Edwin I. Hatch Nuclear Plant
Response to Request for Additional Information:
Power Uprate Submittal

By letter dated January 13, 1995, Georgia Power Company (GPC) submitted a Technical Specifications amendment request for the Edwin I. Hatch Nuclear Plant - Units 1 and 2. The proposed amendment increases the authorized maximum power level for both units from the current limit of 2436 MWt to 2558 MWt. On February 22, 1995, the NRC Staff met with GPC representatives to discuss the proposed Technical Specifications revisions.

By letter dated March 10, 1995, the NRC requested GPC to provide additional information based on the January 13th submittal and data supplied in the February 22nd meeting. Enclosure 1 is GPC's response to the Request for Additional Information. Enclosure 2 provides information relative to Plant Hatch setpoint methodology and calculations as requested by the NRC.

**Edwin I. Hatch Nuclear Plant
Response to RFAI
Power Uprate Submittal**

Figure 19-5 -CALCULATED SUPPRESSION POOL TEMPERATURE RESPONSE FOLLOWING A RECIRCULATION LINE BREAK - UNITS 1 AND 2 (POWER UPRATE)

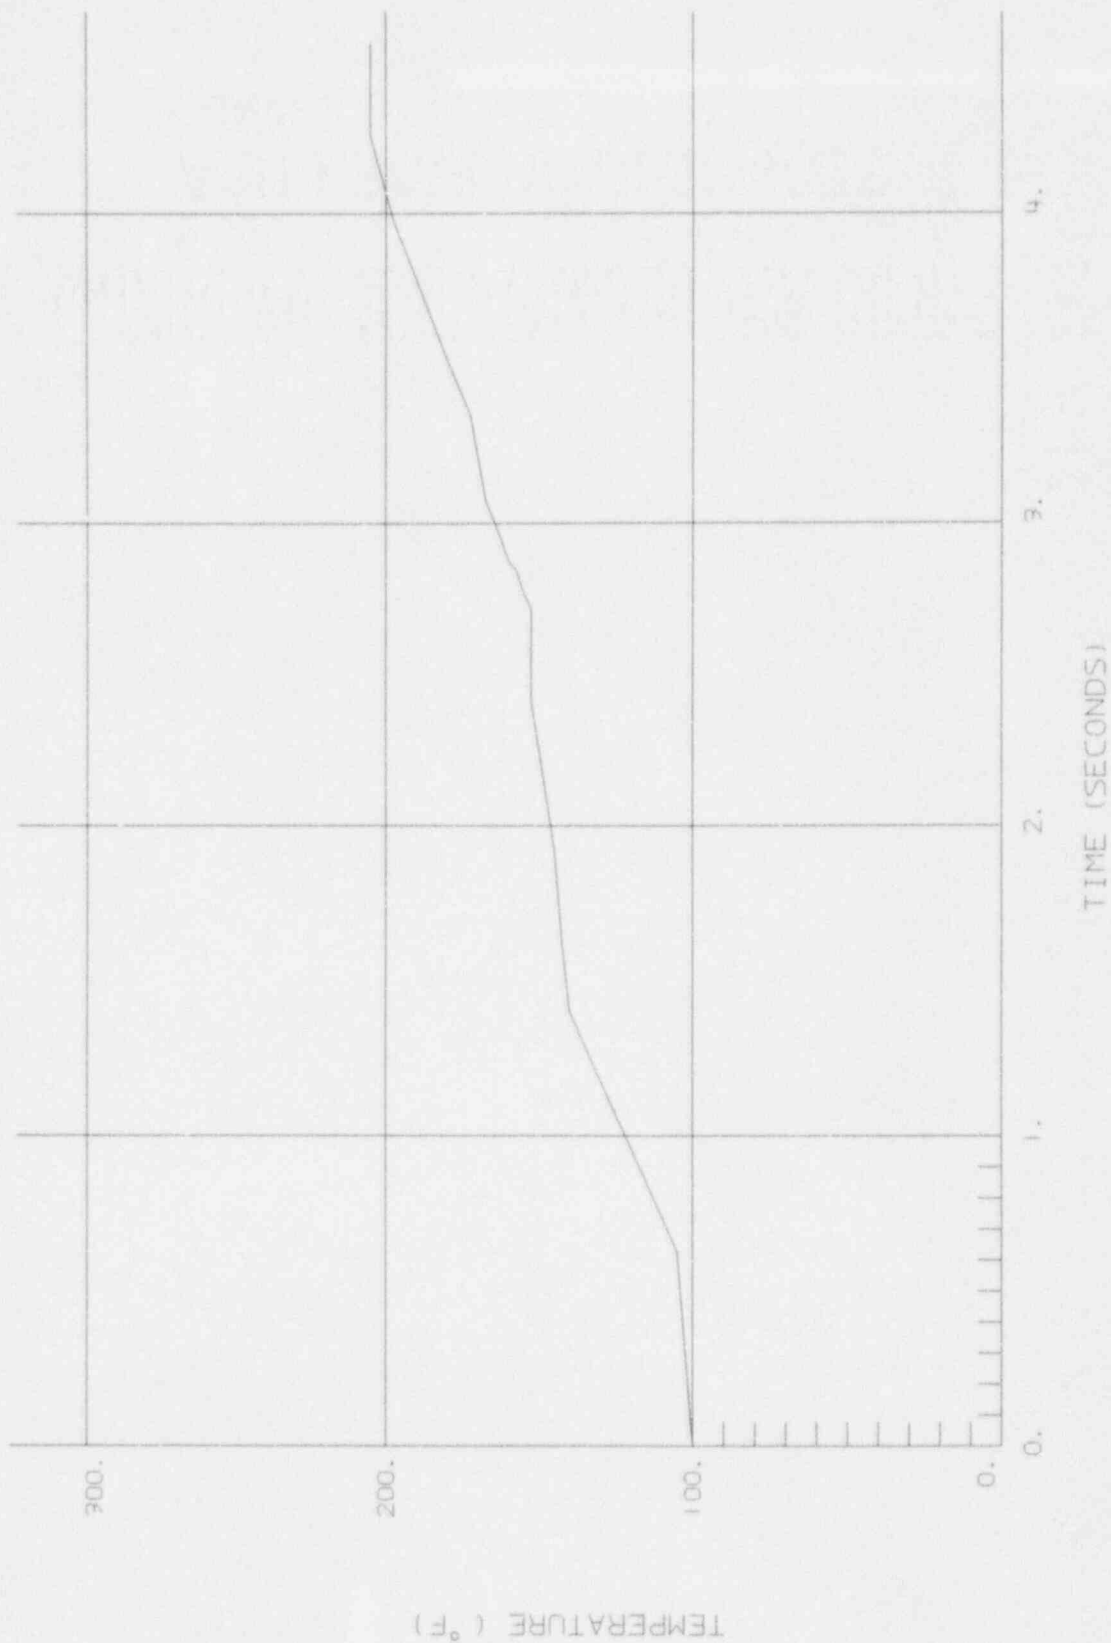
(Section 4.1.1) List the computer codes used for the containment pressure and temperature response. Provide figures showing temperature and pressure changes. Confirm that all other key input parameters except the decay heat codes are the same as in the current Final Safety Analysis Report. If not, provide details and discuss their effects on the pressure and temperature response.

Containment analyses are performed for both short-term and long-term response. Using the M3CPT computer code, short-term containment pressure and temperature response analyses were performed at various reactor operating points. These operating points included rated conditions (uprated power/rated flow) and off-rated conditions (extended load line limit [ELLL] and final feedwater temperature reduction [FFWTR]). For the rated point, the analysis method and input assumptions are identical to those used in the Mark I Long-Term Program (LTP). For off-rated points and the rated point, a detailed blowdown model (LAME) was used to calculate break flow rates and enthalpies. These LAMB break flow values were used as input to M3CPT (containment method used in the LTP). The reason for using LAMB flow values is that the blowdown model built in M3CPT is overly conservative at off-rated conditions. Relative to the long-term response evaluation, the SHEX computer code was used. No significant differences between SHEX and the previous analysis method were identified.

With regard to key input parameter differences (aside from the reactor power level and dome pressure associated with power uprate), the initial drywell temperature increased from 135°F to 150°F. The initial average drywell pressure increased to 1.75 psig, and the initial suppression pool temperature remained at 100°F. (The initial allowable pool temperature increased from 95°F to 100°F in 1988.) For the long-term temperature evaluation, the ANS/ANSI 5.1 decay heat model was used to calculate decay heat values as input to SHEX; whereas, the May-Witt decay heat model was most likely used in the previous analysis. The ANS 5.1 decay heat model is considered more realistic than the other model. In addition, the RHR flow rate is degraded 10 percent to 6900 gpm/pump, consistent with the degradation assumed in the existing SAFER/GESTR-LOCA analysis. All other key input parameters for the power uprate analysis are identical to those for the previous analysis.

Figures 19-1 through 19-4 provide the drywell pressure and temperature responses for Units 1 and 2. The long-term pool temperature response, applicable to both units, is plotted in Figure 19-5.

Figure 21-1 -CALCULATED LONG-TERM WETWELL PRESSURE RESPONSE FOLLOWING
A RECIRCULATION LINE BREAK - UNITS 1 AND 2 (POWER UPSTATE)

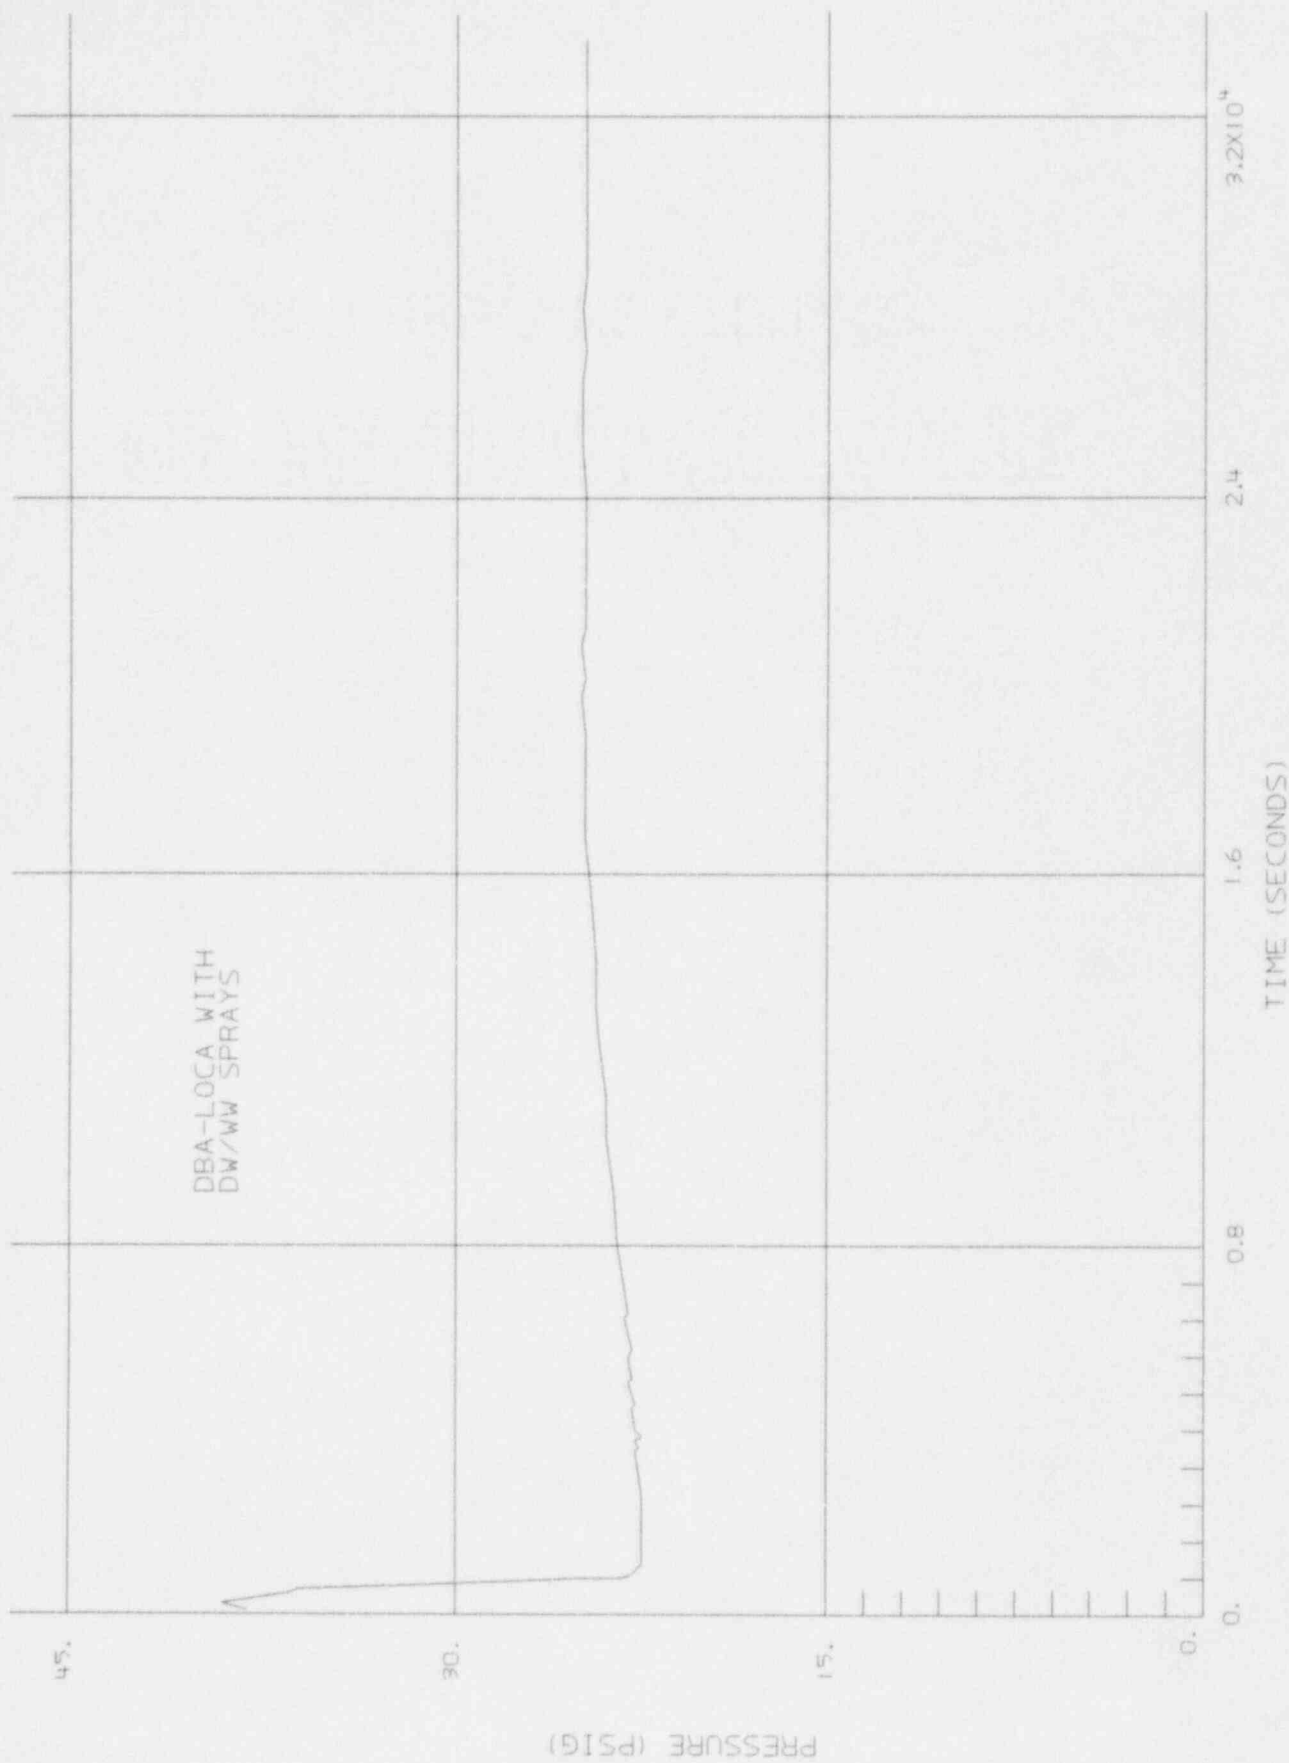
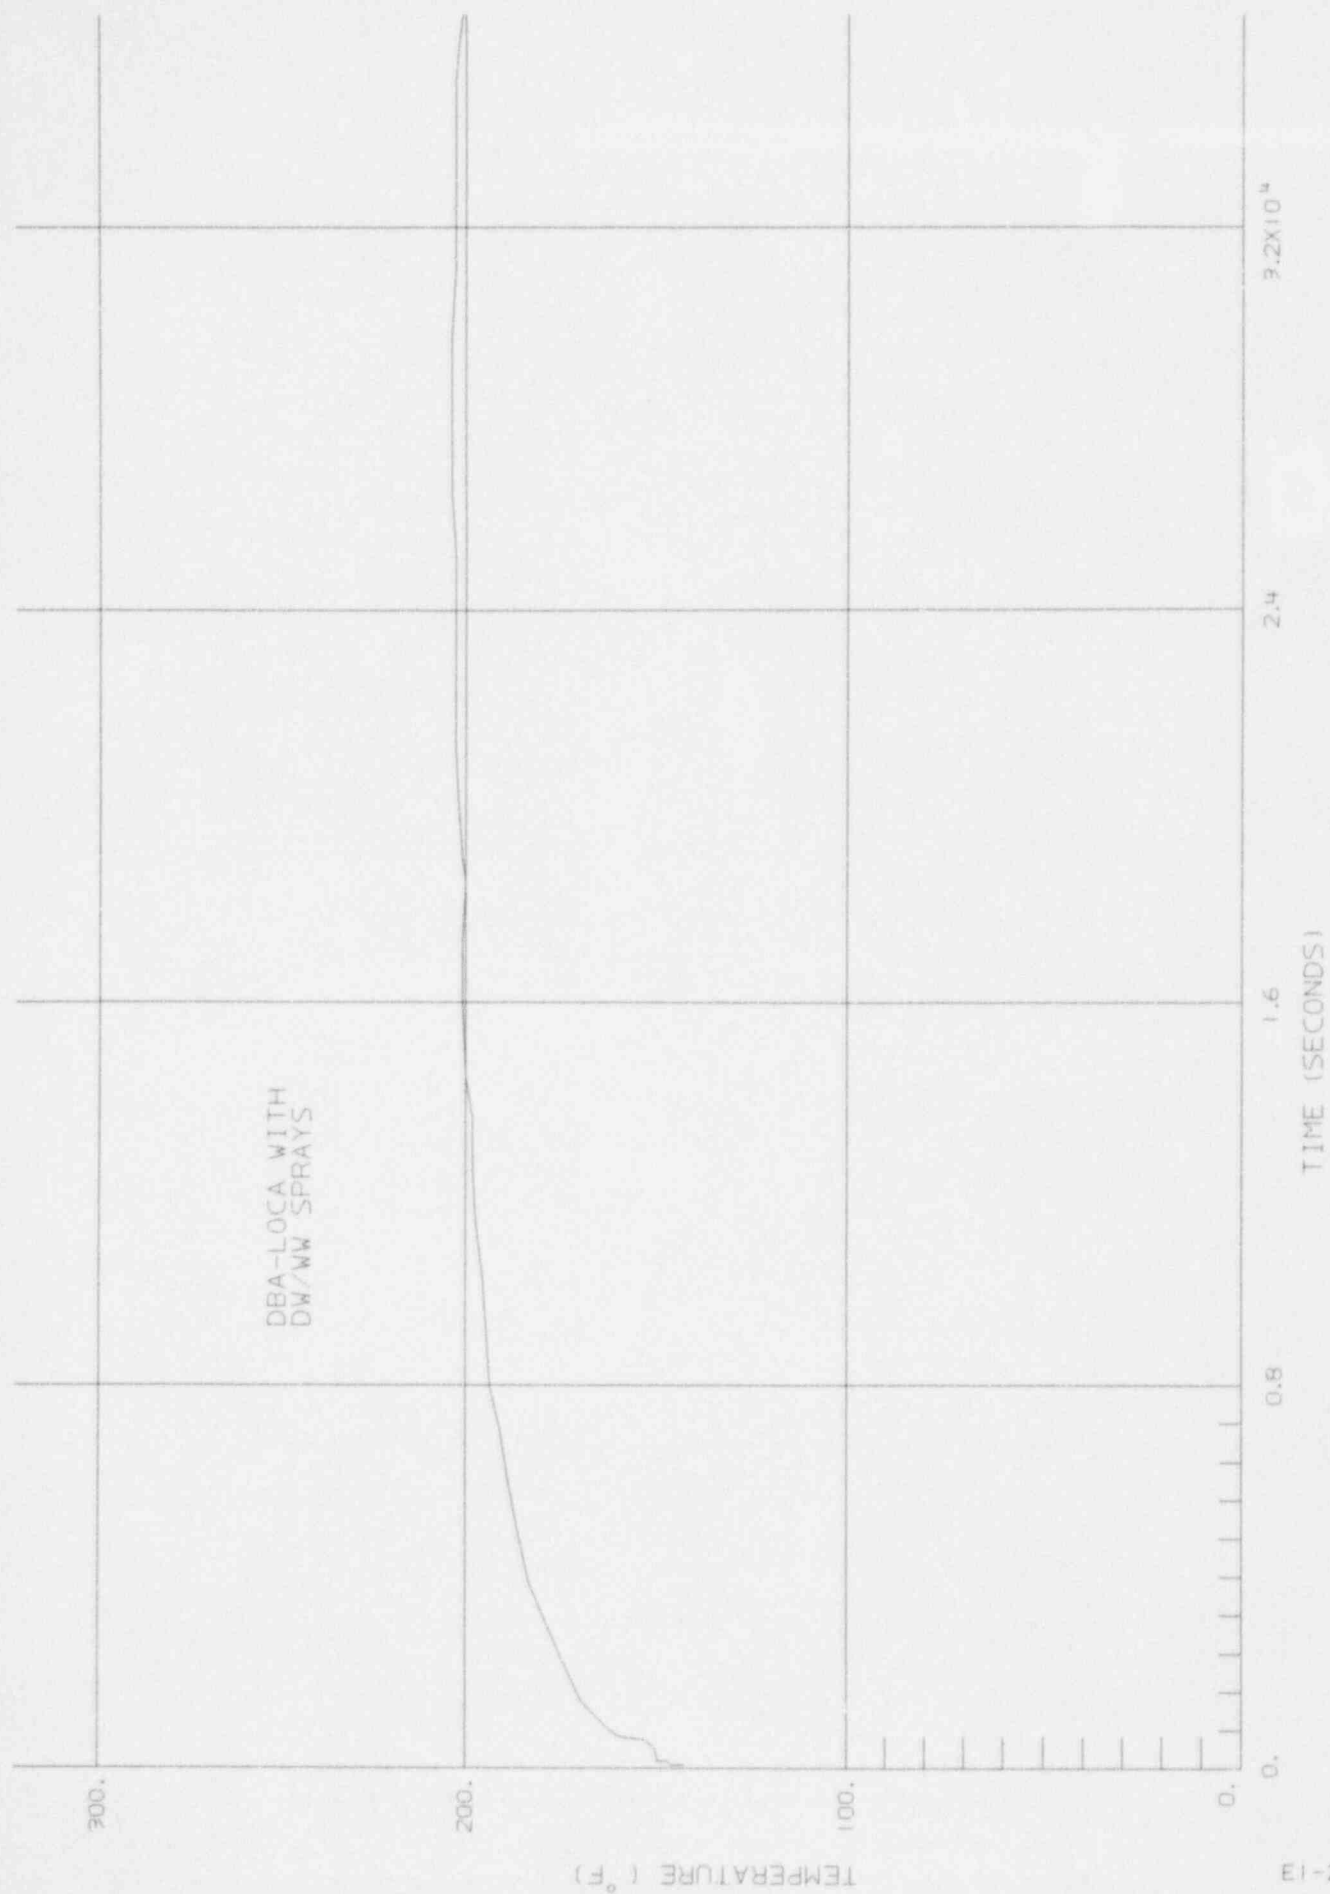
(Section 4.1.1.1) The submittal indicated that the available NPSH for Core Spray (CS) and the residual heat removal (RHR) pumps is adequate for both units. Provide quantitative results to show margins. It is also indicated that for Unit 1, the NPSH for RHR and CS pumps is allowed to take credit for containment pressure. Compare this pressure credit at uprated power with the current/original credit. Provide information regarding the method used to calculate this pressure and the figures that show its variations.

These assumptions have a negligible impact on long-term peak pool temperature but significantly decrease wetwell pressure. Figures 21-1 and 21-2 show the wetwell pressure and suppression pool temperature responses to the DBA-LOCA that were calculated with such assumptions. The peak pool temperature was calculated to be 202°F, with a wetwell pressure of 8.2 psig.

For Unit 1, the wetwell pressure required to satisfy NPSH requirements at 202°F peak pool temperature is approximately 0 psig, as compared to the 8.2 psig wetwell pressure. (See GPC Response to Question 20.) This means that at least an 8.2 psi margin exists for Unit 1, as compared to a 5 psi margin shown in the current FSAR.

For Unit 2, the peak pool design temperature for NPSH requirements is approximately 220°F for both CS and all RHR pumps, as compared to the 202°F peak pool temperature. (See GPC Response to Question 20.) Namely, an 18°F margin exists for Unit 2.
